<b>Project</b>	<b>IEEE 802.16 Broadband Wireless Access Working Group</b>	
<b>Title</b>	<b>UL Access Region Size Request for Semi-Distributed RS</b>	
<b>Date:</b>	<b>07-05-2007</b>	
Source(s)	Eugene Visotsky <a href="mailto:eugenev@motorola.com">eugenev@motorola.com</a> Roger Peterson Motorola Labs 1301 E. Algonquin Road, Schaumburg, IL 60196 USA	Shyamal Ramachandran <a href="mailto:shyamal.ramachandran@motorola.com">shyamal.ramachandran@motorola.com</a> Motorola Inc. 1064 Greenwood Blvd. Suite 400 Lake Mary, FL 32746 USA
Re:	This document is in response to call for technical proposals IEEE 802.16j-07/019 dated 06/07/2007. This document proposes text regarding signaling to enable UL Access Region Size Request for insertion in baseline document IEEE 802.16j-06/026r4.	
Abstract	This contribution proposes signaling to enable UL Access Region Size Request from an RS to an MR-BS with semi-decentralized scheduling.

# UL Access Region Size Request for Semi-Distributed RS

Figure XXX – RS UL Size Request Header

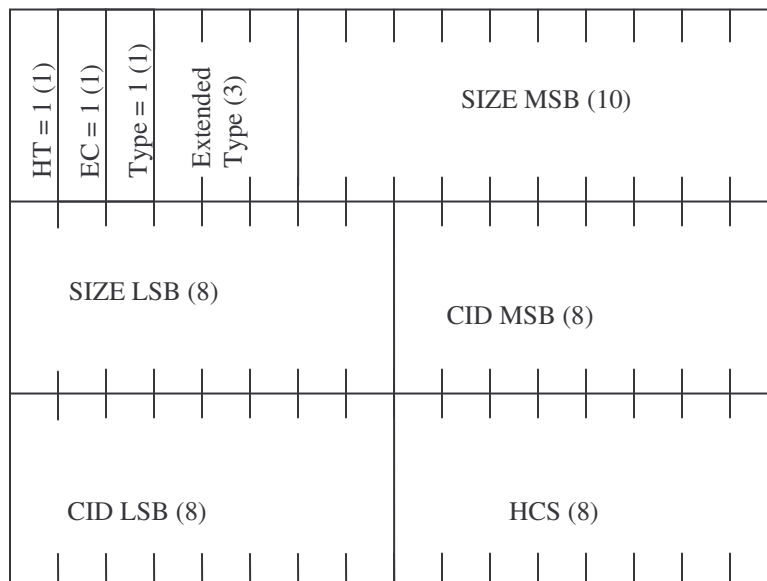
[Insert new subclause 6.3.2.1.2.2.2.5 as follows:]

6.3.2.1.2.2.2.5 RS UL Size Request Header

An RS may optionally request size for its region of the access zone from the superordinate RS/MR-BS by sending the RS UL Size Request Header. The header specifies the requested size of the RS region of the uplink access zone in ODFMA slots. The header format is as follows:

Syntax	Size	Notes
MAC Header(){		
HT	1 bit	Shall be set to 1
EC	1 bit	Shall be set to 1
Type	1 bit	Shall be set to 1
Extended TYPE	3 bits	Shall be set to 0100 for RS UL Size Request Header
Size	18 bits	Number of OFDMA slots requested for the RS portion of the UL access zone
CID	16 bits	Basic CID of the RS
HCS	8 bits	Header check sequence
}
